D . R . B . S U B M I T T A L

P A V I L I O N S A T S A N M A T E O

SITE PLAN / SITE DETAILS

| NO. | DATE | REVISIONS | REMARKS | BY |
|----------------------------------|------|--|---------|-----------|
| | | SITE PLAN FOR BUILDING PERMIT (AREA OF CONTROL) | | DATE |

SITE PLAN
SCALE 1"=60'

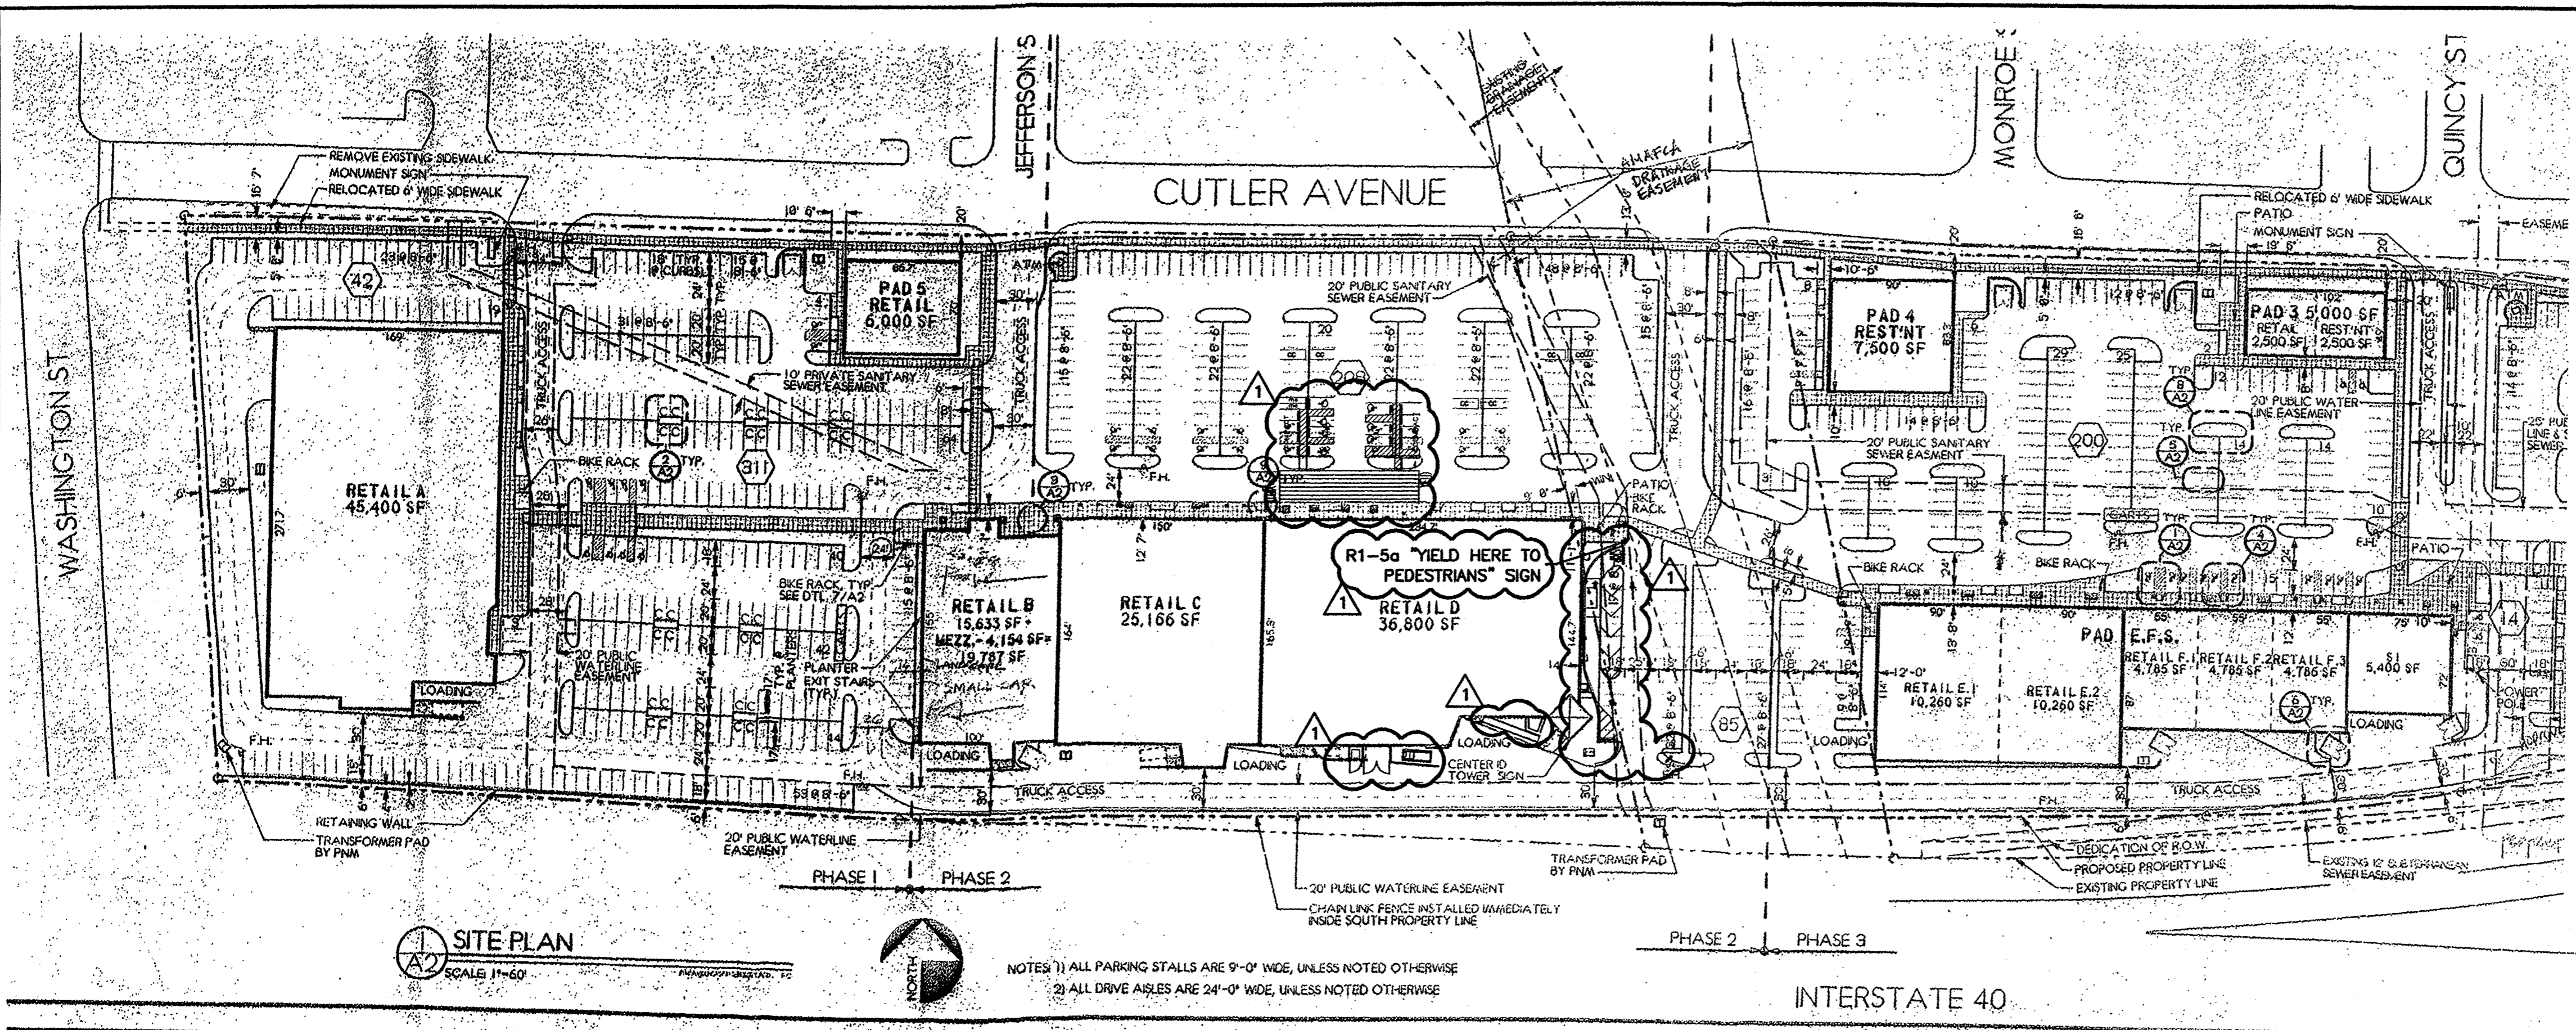
| 1 | 8/22/12 | REVISED ADA HANDICAP PARKING, ADDED DRIVE THRU PHARMACY, MOVED DUMPSTER RELOCATION SEE SHEET C3 |

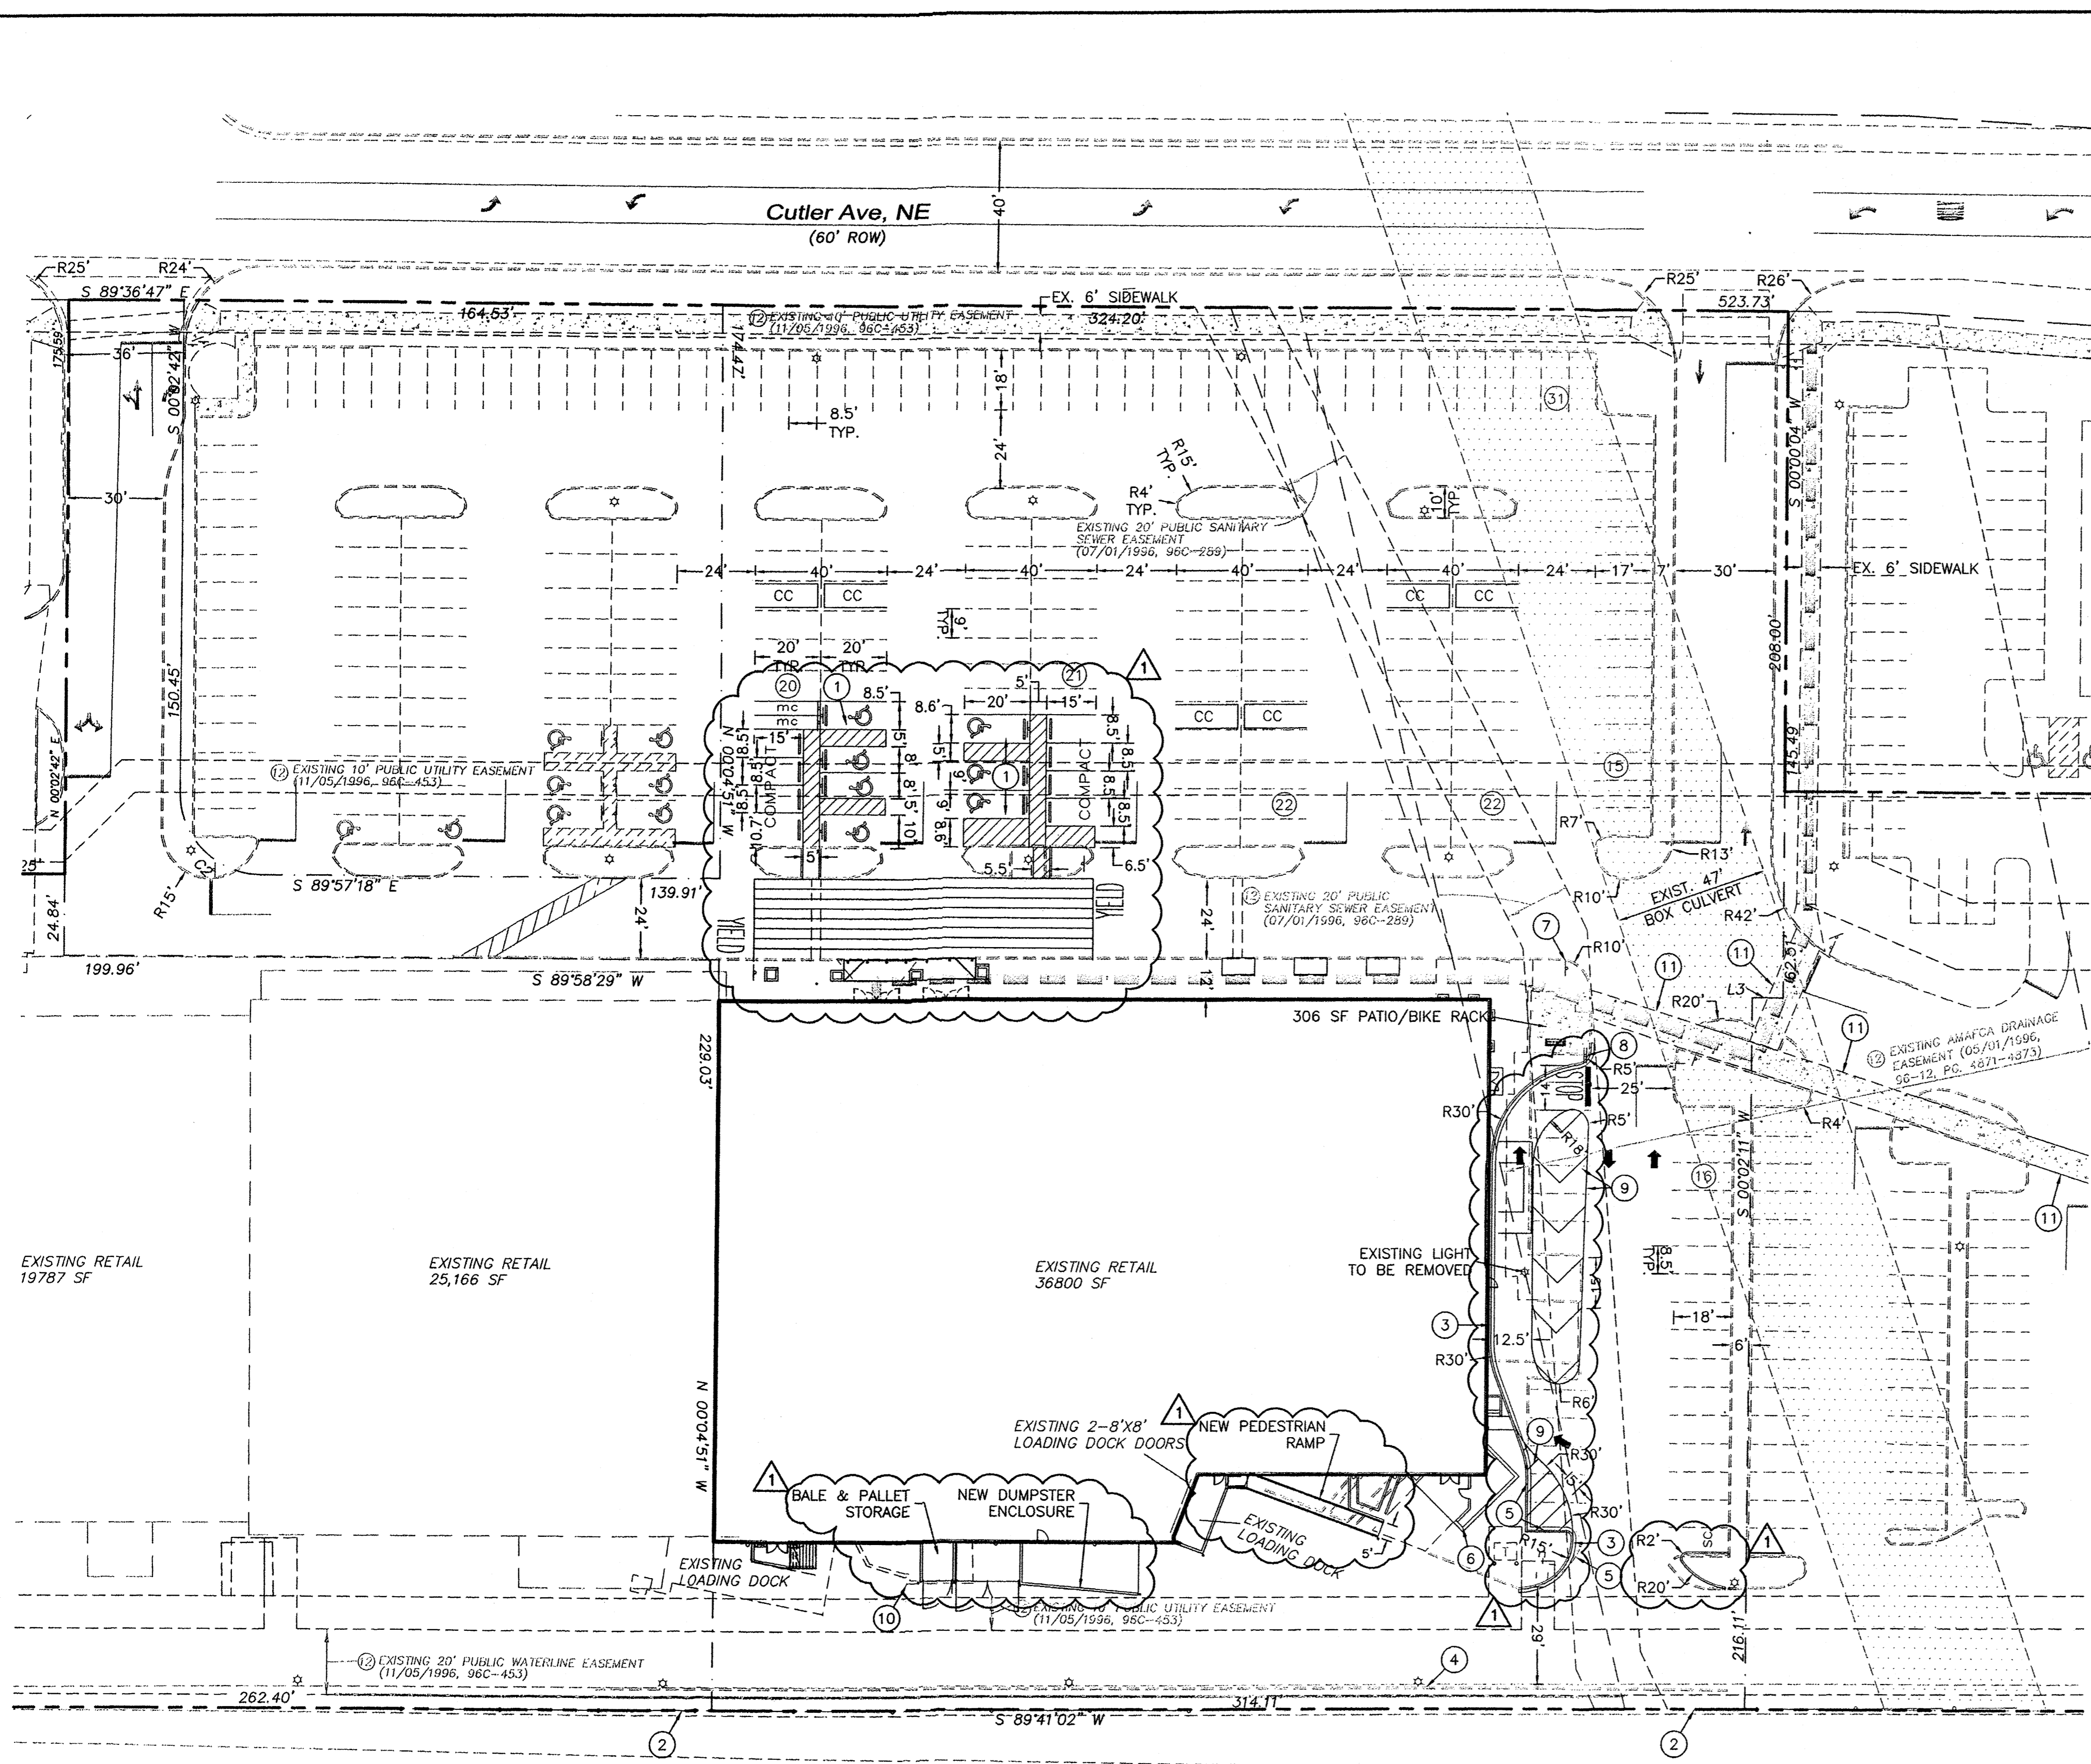
| NO. | DATE | REVISIONS | REMARKS | BY |
|----------------------------------|------|--|---------|-----------|
| 8-22-12 | | ADDED PHARMACY DRIVE-UP, MODIFIED ADA PARKING & DUMPSTERS, ADDED PEDESTRIAN RAMP | | VC |

LANDSCAPE PLAN

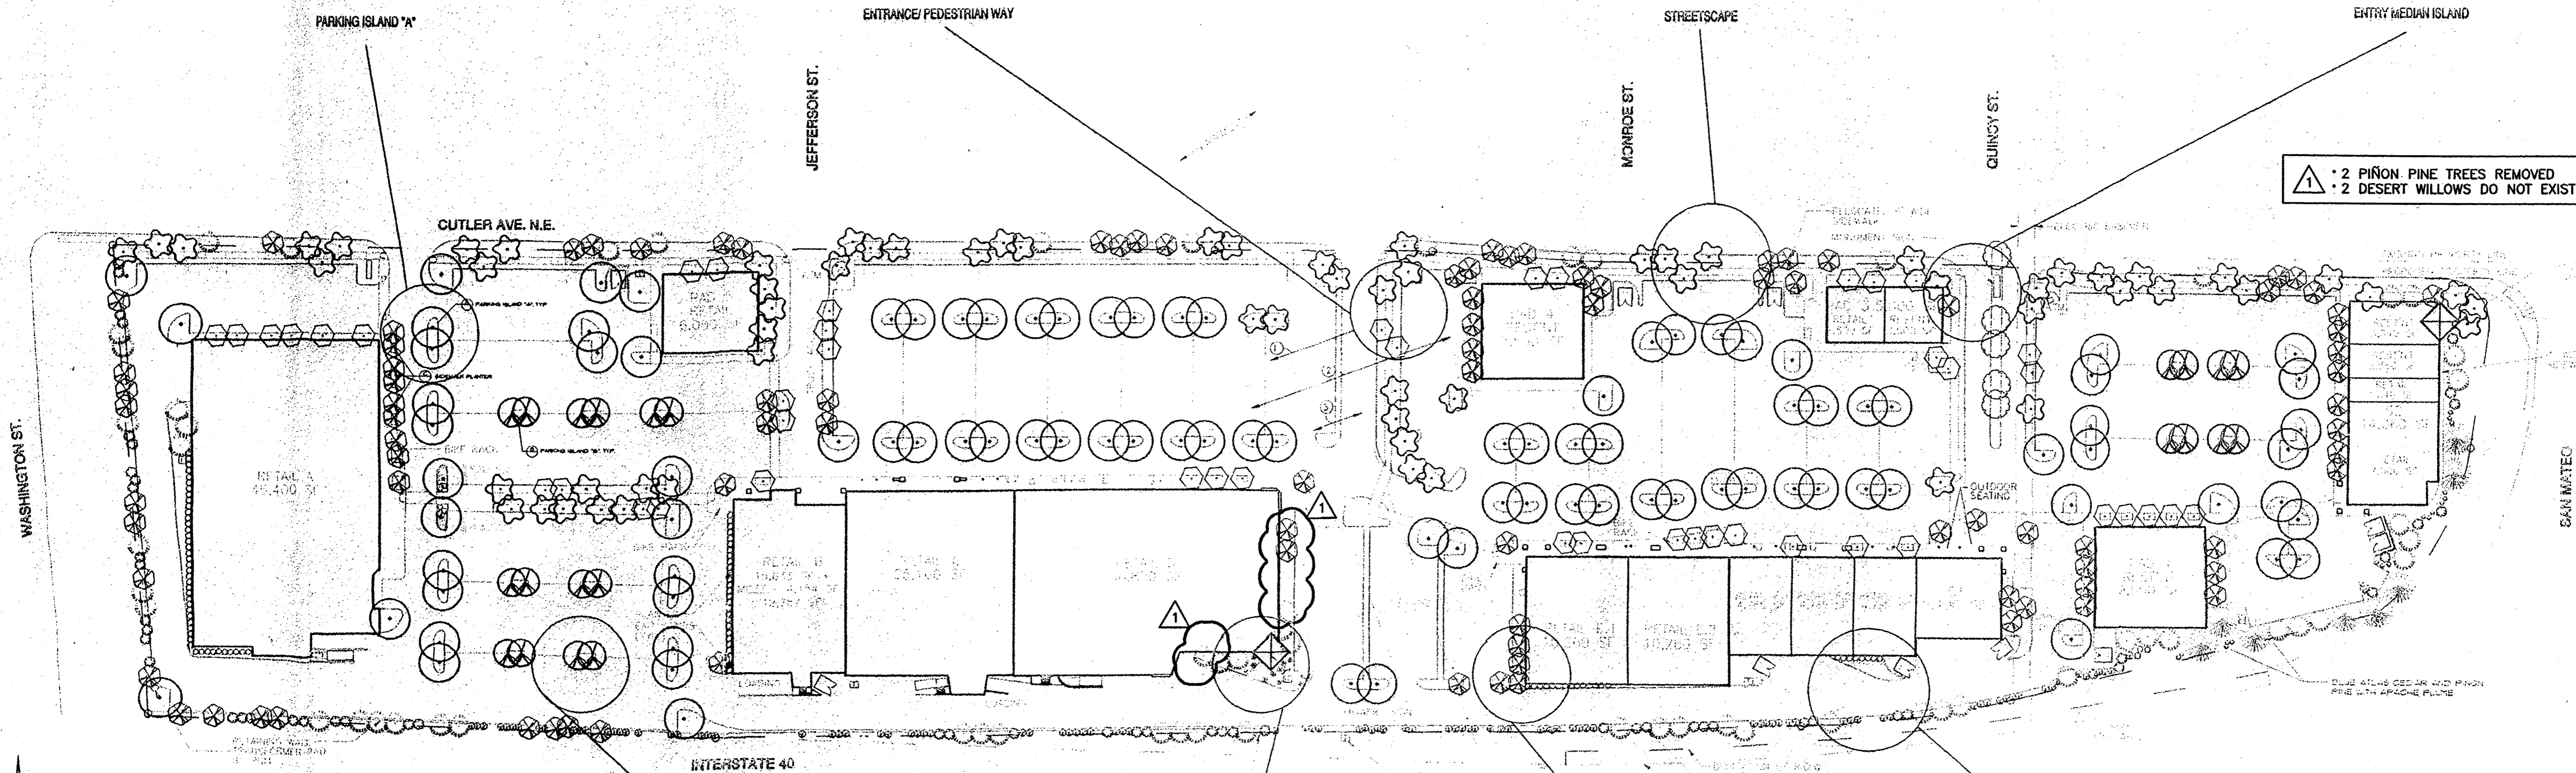
2 PIÑON PINE TREES REMOVED
2 DESERT WILLOWS DO NOT EXIST TO DATE

| NO. | DATE | REVISIONS |
|-----|---------|------------------------------------|
| 1 | 8/22/12 | EXISTING LANDSCAPING TO BE REMOVED |
